Village of Mukwonago  
**Notice of Meeting and Agenda**

**PLAN COMMISSION MEETING**  
**Tuesday, June 8, 2021**

- 6.1 Discussion and possible recommendation to Village Board **RESOLUTION 2021- 53** to approve a Conditional Use for 809 S Rochester Street, for Carl Goede / Rivers Edge Car Wash; Parcel MUKV 2009-978-004

# River's Edge Car Wash

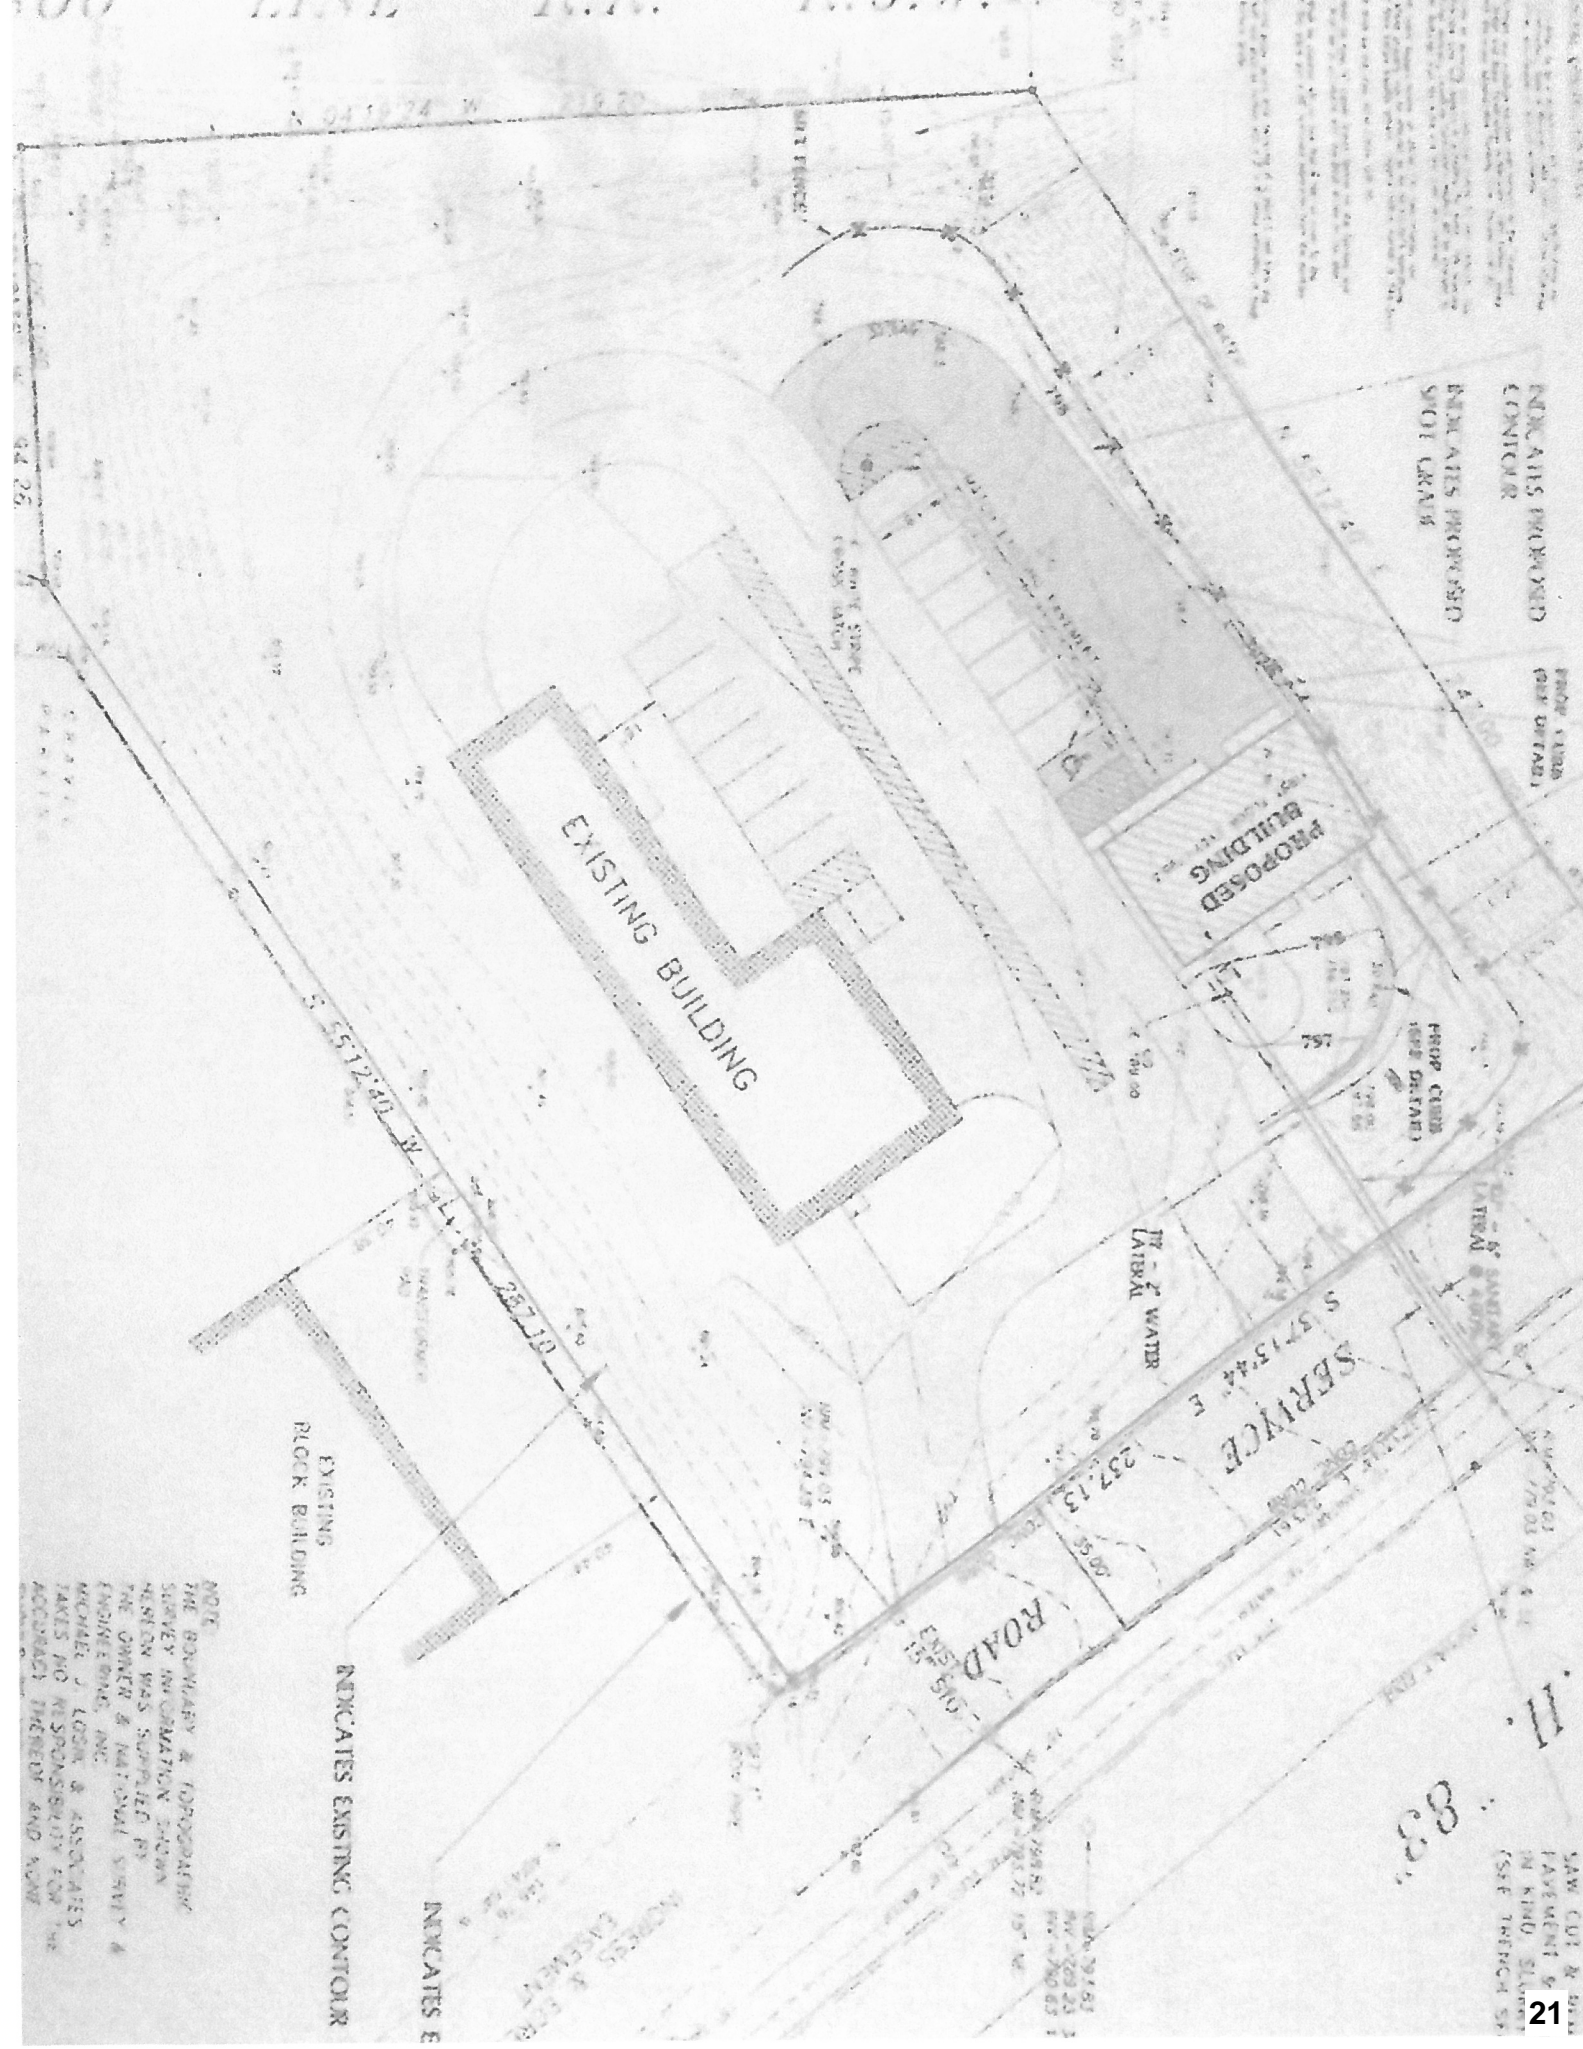
<b>Engineering</b>	See letter from R-M
<b>Public Works</b>	No issues.
<b>Utilities</b>	No comment
<b>Police</b>	Would like to see vegetation kept near a maximum height of 3ft. (36 inches)
<b>Fire</b>	No comment
<b>Building Inspection</b>	No comment
<b>Planning</b>	The landscaping plan of the property is compliant with regard to the number of trees. These existing trees are located on the south property line and rear property line. Section 100-152 (j) (1) of the municipal code states that a minimum of two trees are to be planted or retained in each front yard and each street side yard. Staff recommends that approval of the modifications of the site include the planting of two additional shade trees subject to the locations being approved by the planner prior to planting.

9. The applicant applies for and receiving approval for all new signage.
10. The only exterior modification to the structure at this time shall be additional landscaping, retaining wall, and vacuum stalls.

11. Landscaping shall be maintained at three feet.
12. Two additional shade trees shall be planted within the front yard of the property species, size and location to be coordinated with the Planner prior to installation.

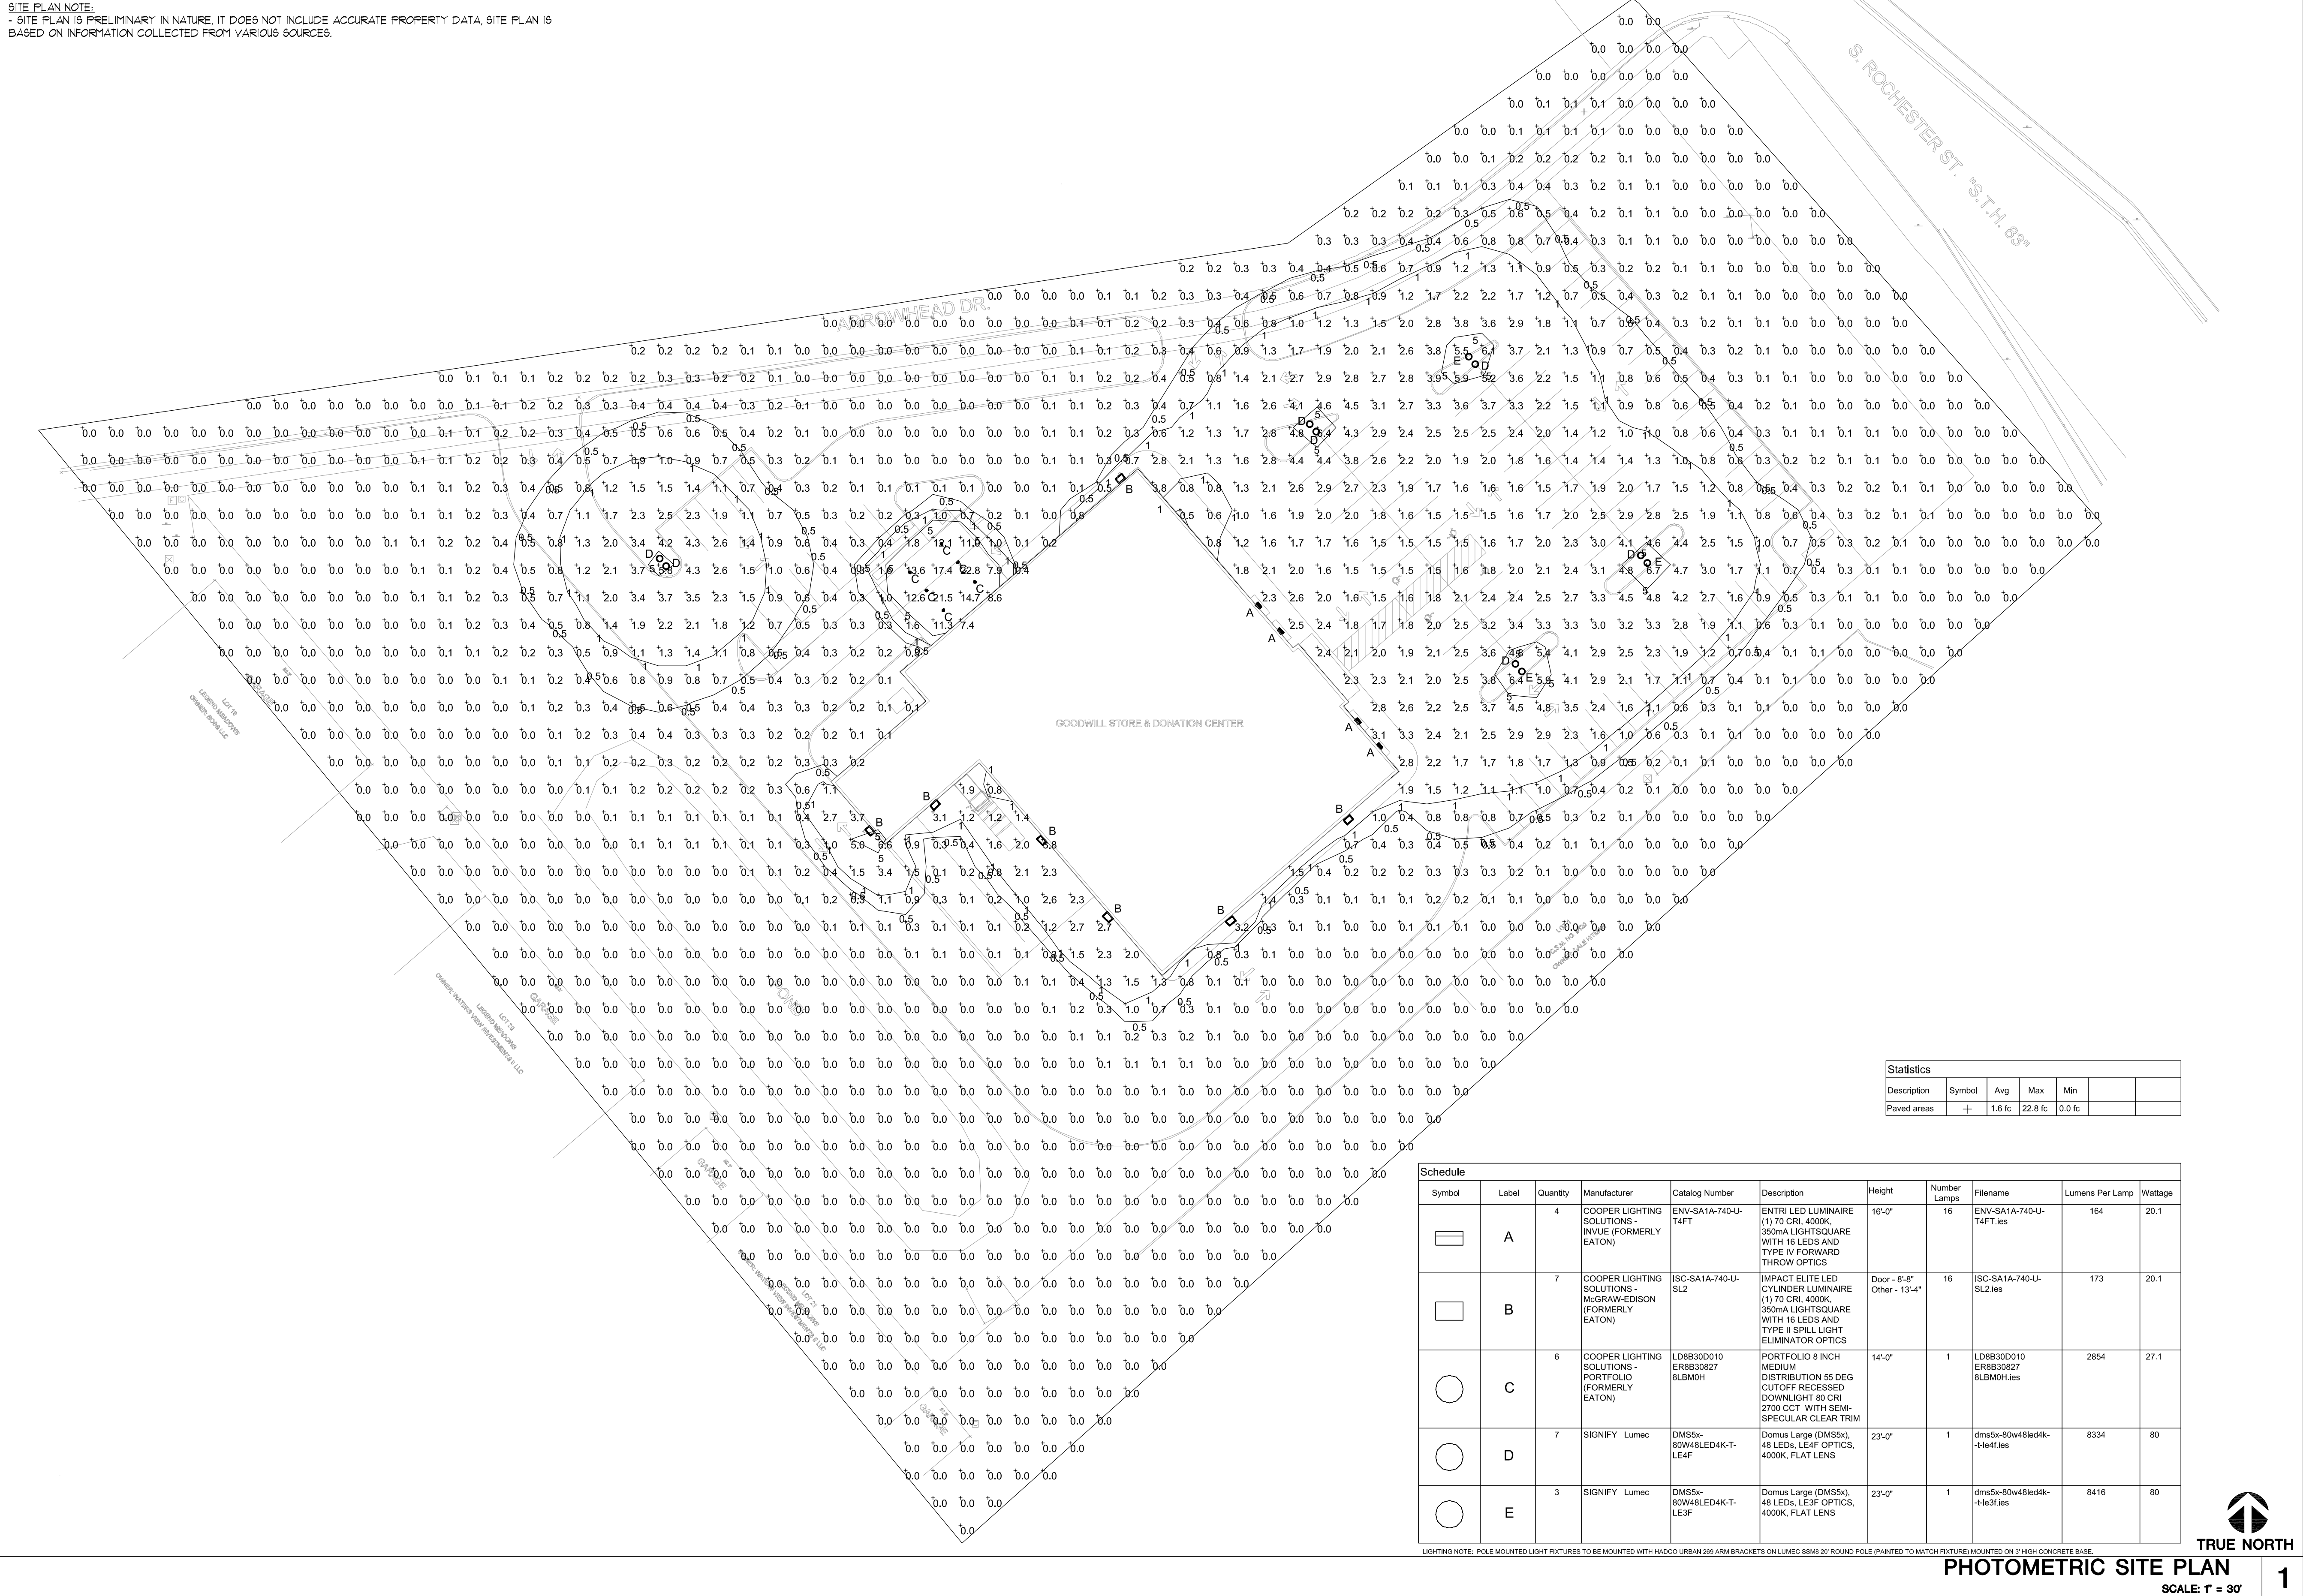
Staff's concern is that this area of the Village South of the interstate has over time developed a complex lighting pattern. Because there are so many styles staff does suggest that a simple pole with LED over head fixture might be the best options. However, if an ornamental lighting fixture is desired staff believes that the original approval to have lighting similar to 1231 S. Rochester is the preferred ornamental light as the properties are within the same block and the parking lots adjoin.

At the April 13<sup>th</sup> Plan Commission meeting, it was suggested that we possibly match the pole mounted lighting at an adjacent property. This was the first that we had heard of this suggestion of a pole topped "lantern style" fixture, and we disagree that the fixture would look appropriate for our development. The lantern fixtures are of a vintage style, whereas our building has a more progressive/modern style. The building at the adjacent property has a more "residential" look to it, making the lantern style fixtures look more appropriate. The scale of the lantern fixtures and poles are fairly small in stature, almost pedestrian in scale, and would require a greater number throughout the parking lot in order to provide enough adequate lighting. While they would be mounted on 3' tall concrete bases, drivers would have more hazards to navigate in the parking lot. The lower fixture height of the lantern lights (probably around 16') also has a greater potential for causing glare, when compared to our proposed lights at the higher 23'.

We believe that the bell-style fixtures, originally suggested for our site are more appropriate for our development. This style fixture has been suggested and used at some recent Mukwonago projects, even a very modern looking credit union. I have also seen this similar fixture used by other municipalities, and it actually works well with various building styles and sizes.
